W3F1-2017-0018

Subject: Supplement to License Amendment Request to Revise Technical Specification 3/4.3.2 to Relocate Surveillance Frequency Requirements for Engineered Safety Features Actuation System (ESFAS) Subgroup Relays to the Surveillance Frequency Control Program (SFCP)  
Waterford Steam Electric Station, Unit 3 (Waterford 3)  
Docket No. 50-382  
License No. NPF-38

**Further Clarifications Pertaining to Entergy Response of January 26, 2017  
Regarding License Amendment Request to  
Relocate Surveillance Frequency Requirements for  
Engineered Safety Features Actuation System (ESFAS) Subgroup Relays to the  
Surveillance Frequency Control Program (SFCP)**

**B424**  
**HEET 1646**

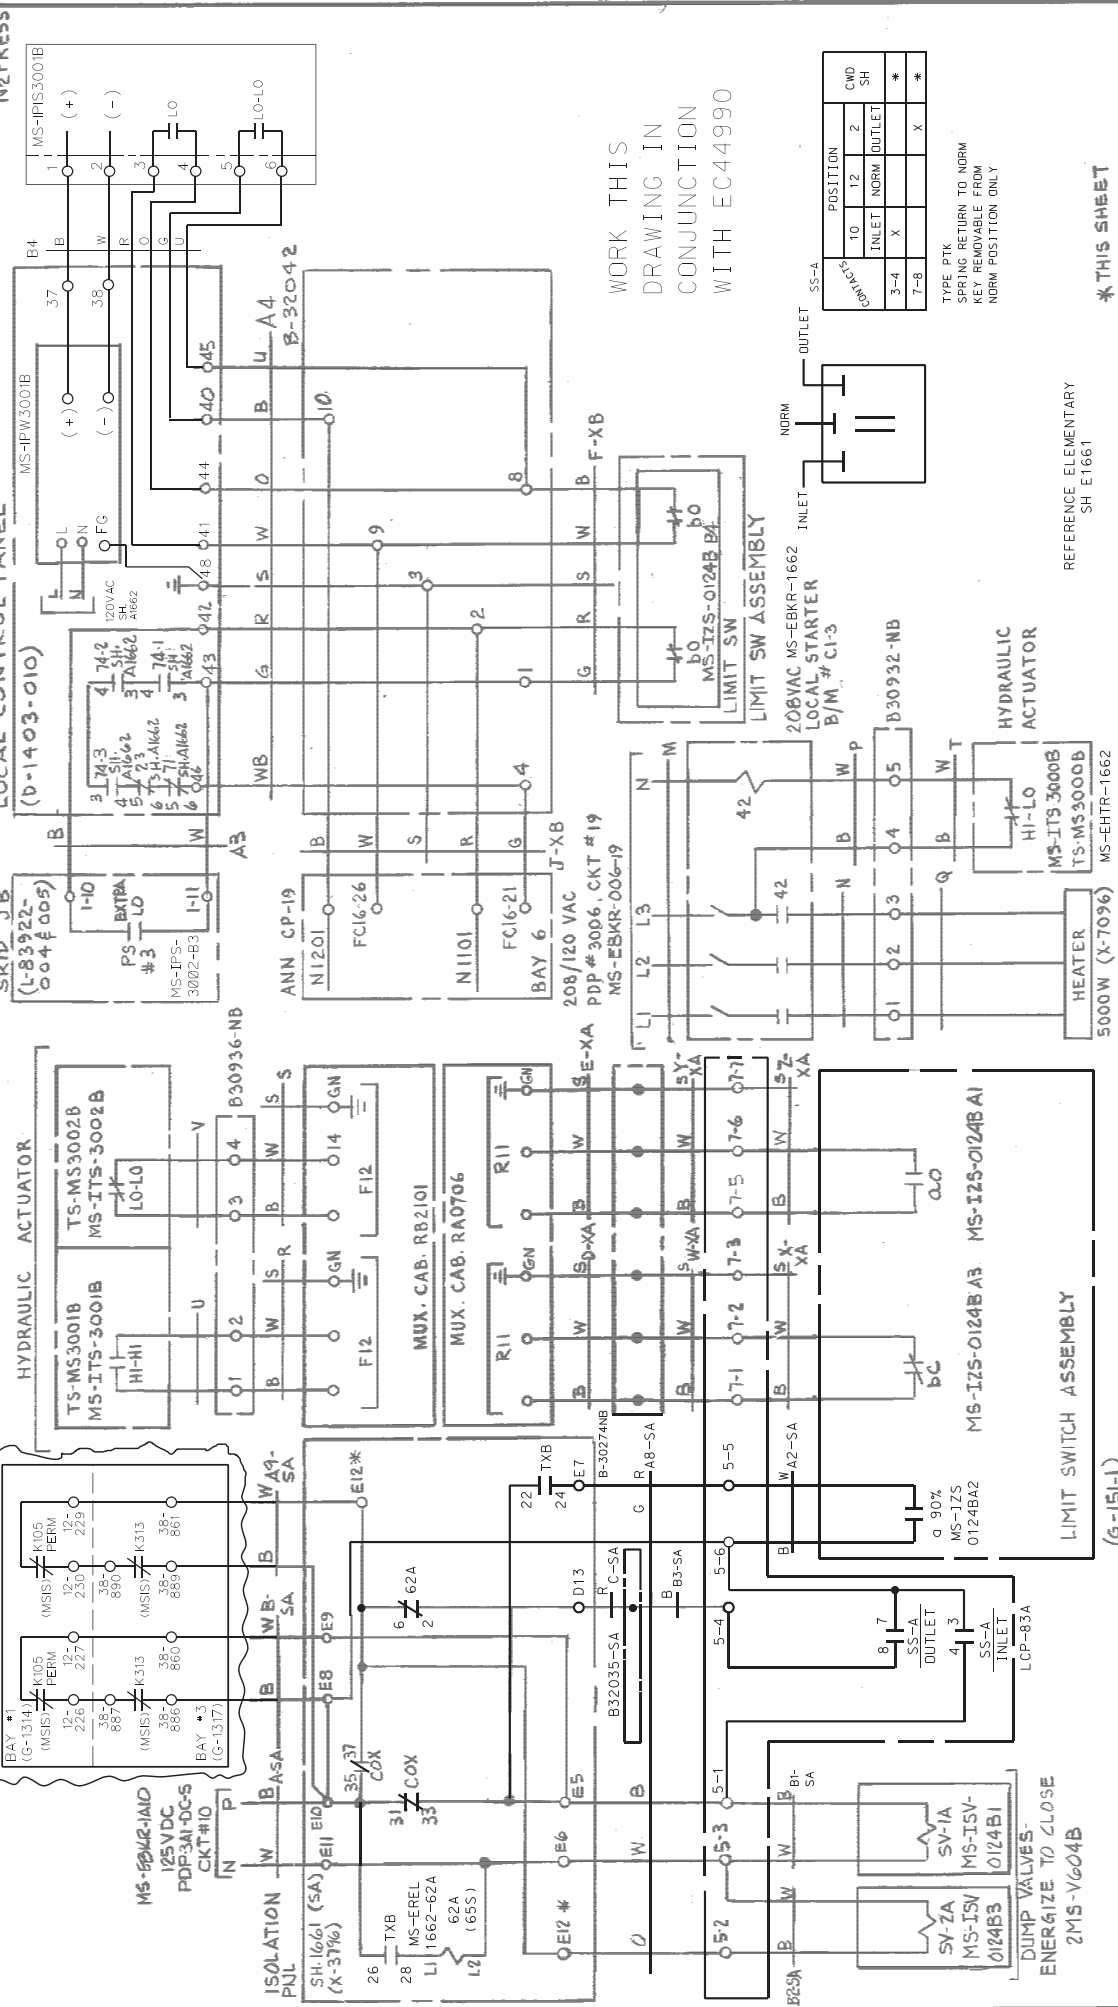
In order to assess compliance to IEEE 279, Clause 4.10, the staff requests that the licensee explain operation of the MSIVs and the CSAS valves. The explanation should describe the total number of affected valves, the total number of solenoid valves per affected valve, the arrangement of the hydraulic dump piping/tubing to dump the hydraulic fluid indicating the operation of the solenoid valves, and the total number and combinations of solenoid valves required to actuate each of the affected valves. Please indicate the nomenclature of the valves corresponding to the schematic sketches included within the LAR and the January 26, 2017, response.

As seen on CWD-1646, ESFAS Train A K305 deenergizes (opens) SV-1A, MS-ISV-0124-A1, and SV-2A, MS-ISV-0124-A3. Both of these solenoid valves are required to open to align the two poppet valves which make up Dump Valve A. CWD-1647 shows ESFAS Train B K305 deenergizes (opens) SV-1B, MS-ISV-0124-A2, and SV-2B, MS-ISV-0124-A4. Both of these
